U.S. Application Serial No.: 10/666,564
Supplemental Amendment Dated November 3, 2006
In further response to Office Action dated June 30, 2006

Amendments to the Drawings:

Perspective Drawing To Clarify The Difference
Between Prior Art And Structures.

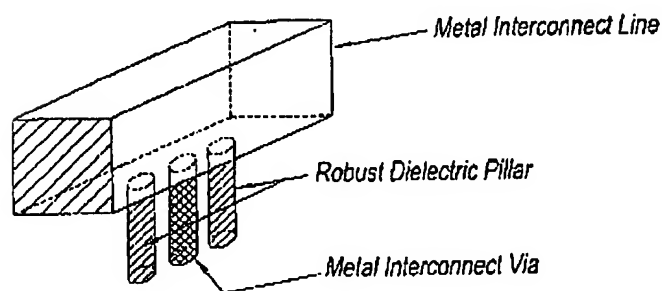
In addition, Applicants enclose the following Perspective Drawing to clarify the difference between the interconnect structures of the instant invention and the prior art:

The interconnect structures according to the present invention has discrete dielectric pillars supporting the lines so that the air gap is not only situated between the lines laterally but also in a substantial portion of the region below the lines, as depicted herein above in the Perspective Drawing which shows the difference between the interconnect structures of the instant invention and those of the prior art.
